QUEENSLAND FLOODS COMMISSION OF INQUIRY

**Technical Review of Flood Frequency
Analysis Report by WMA Water (18
September 2011), specifically as it
relates to Ipswich City Council**

Ipswich City Council

R. B18414.003.00.doc
October 2011

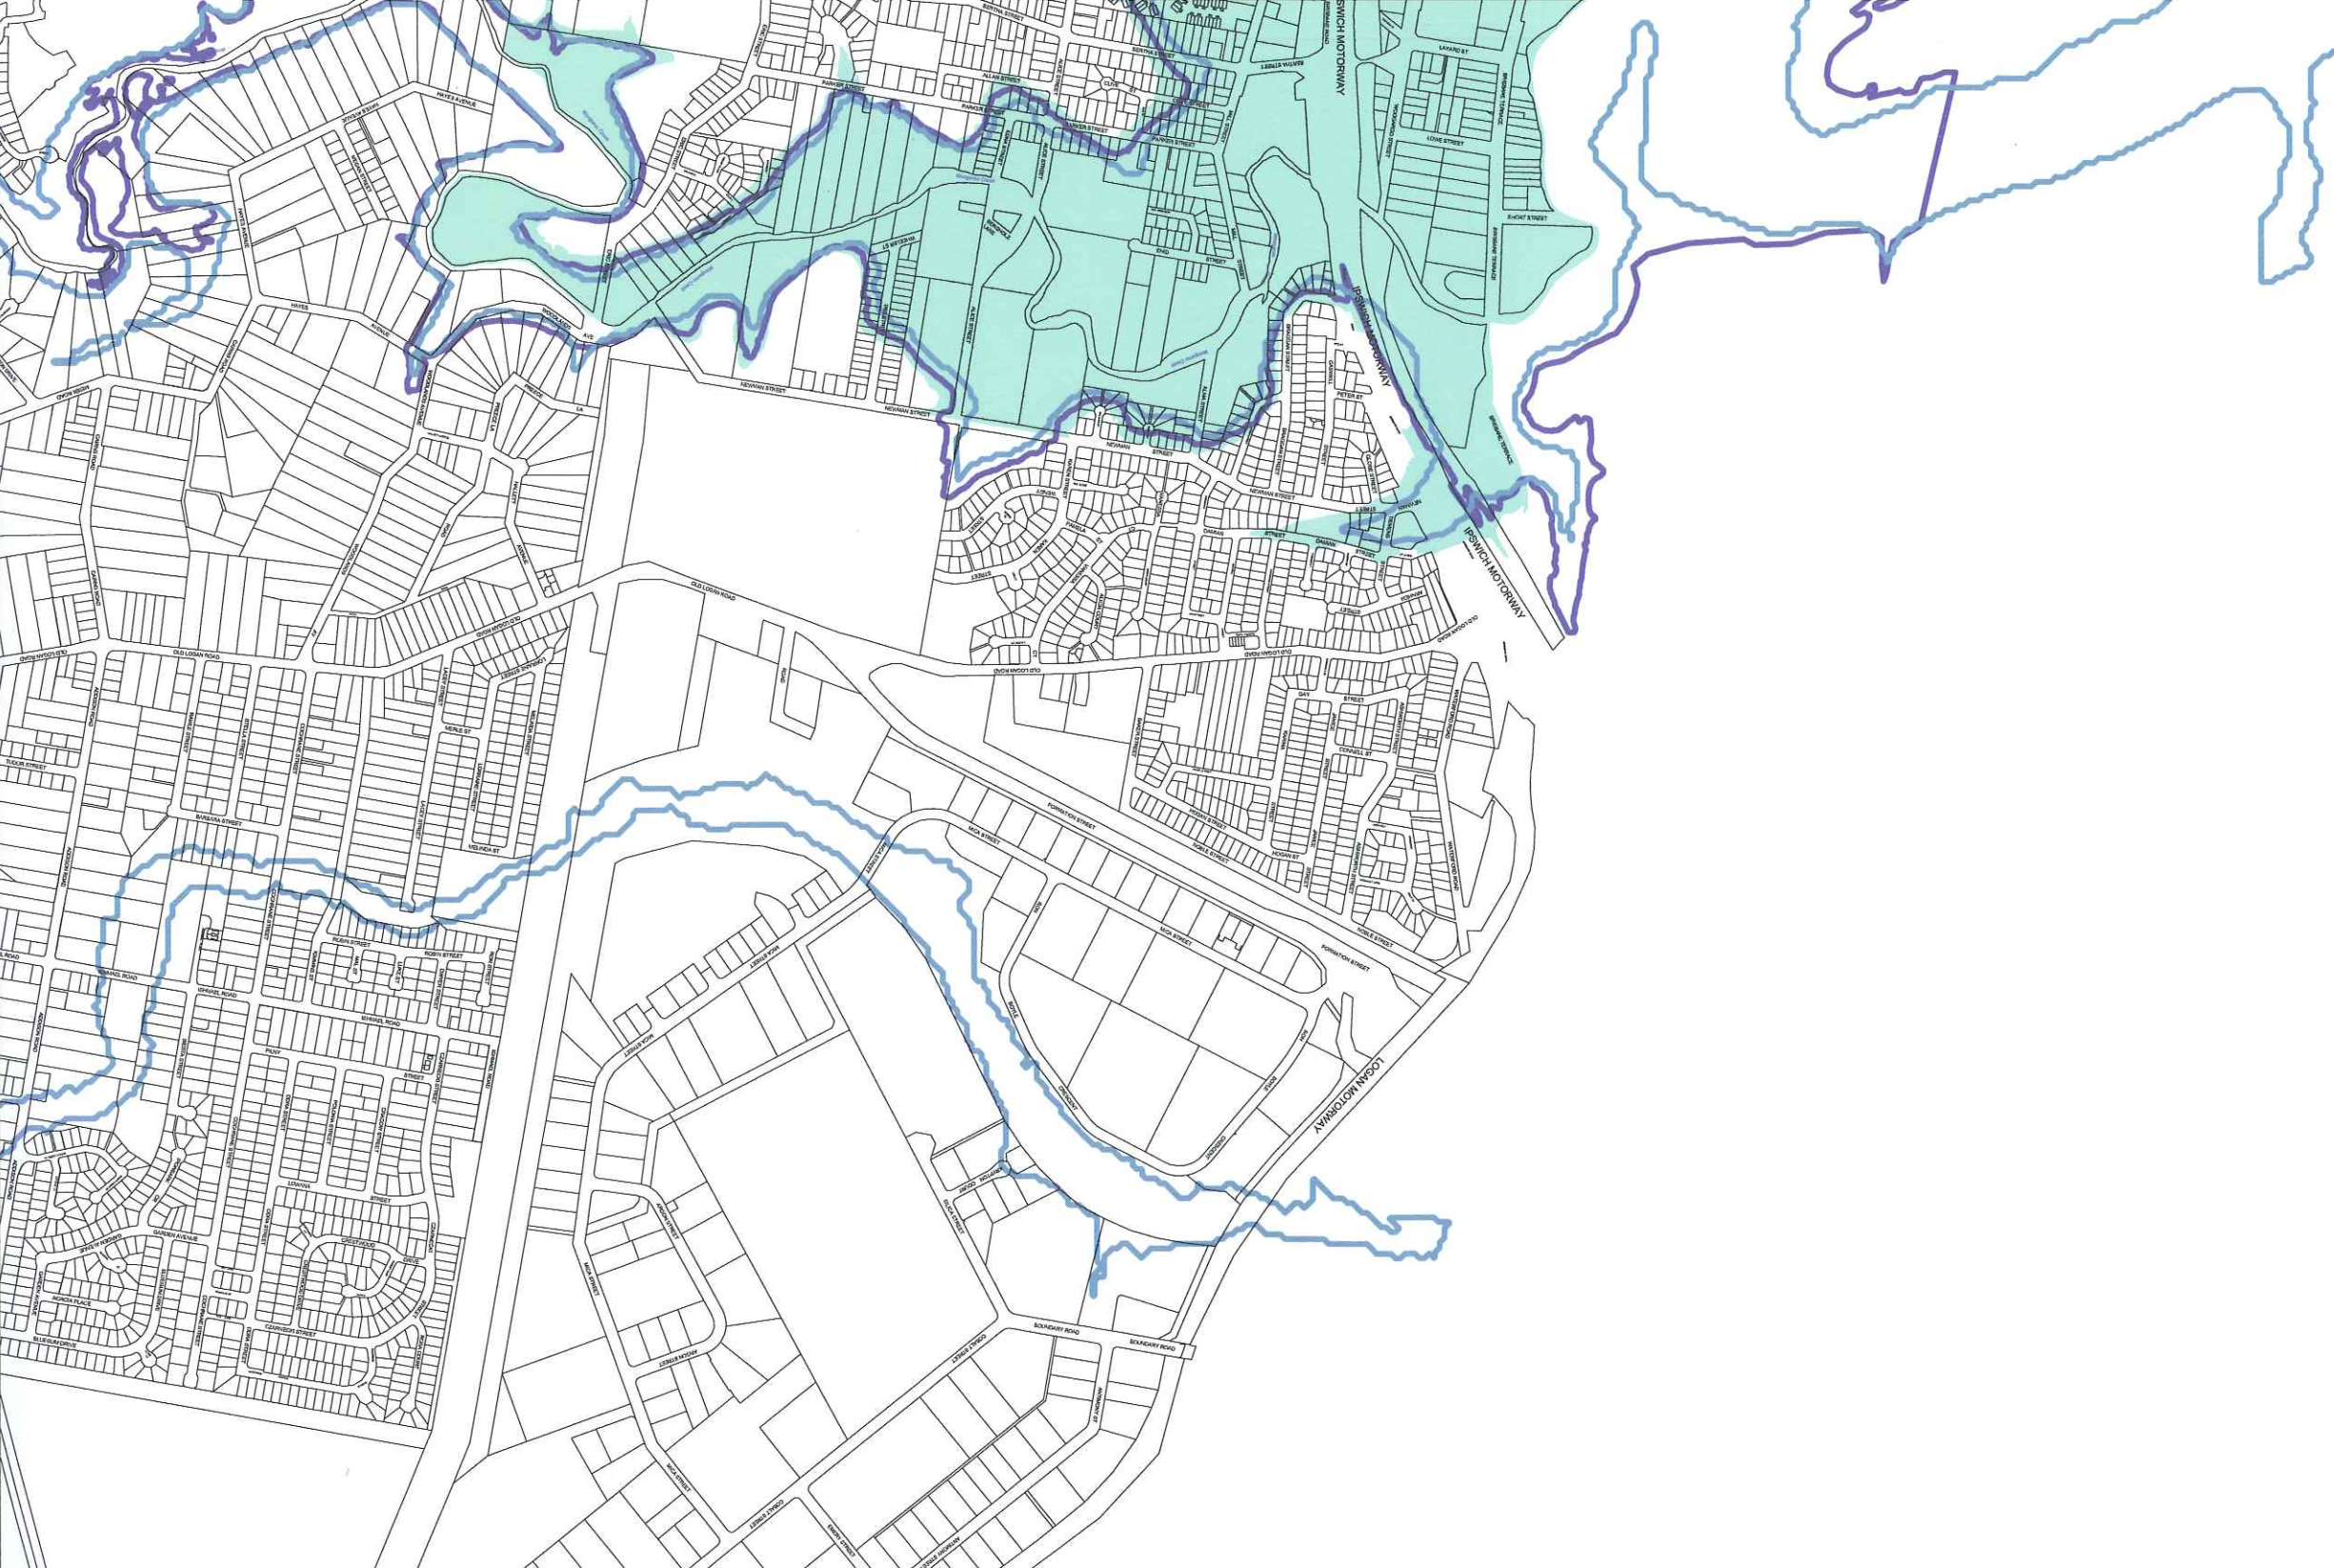
Extracts of Council's flood maps which supplement this data are included in Appendix C.

1. The existing 1% AEP Design Level used by WMA Water for the two Ipswich properties is over one metre lower than the 1% AEP design levels as advised by Ipswich City Council.

2. The 2011 surveyed flood level for the Bridge Street property do not accord with Ipswich City Council's reported level.
3. Given the 90% uncertainty range in the determination of the 1% AEP flood estimate by WMA Water, too great a reliance may be placed on the WMA Water 1% AEP design level line. I am strongly of the view that further review ought to be carried out before any conclusions as to the accuracy of the existing Council 1% AEP design levels are reached. In particular, the WS DOS study needs to be completed and the results considered.
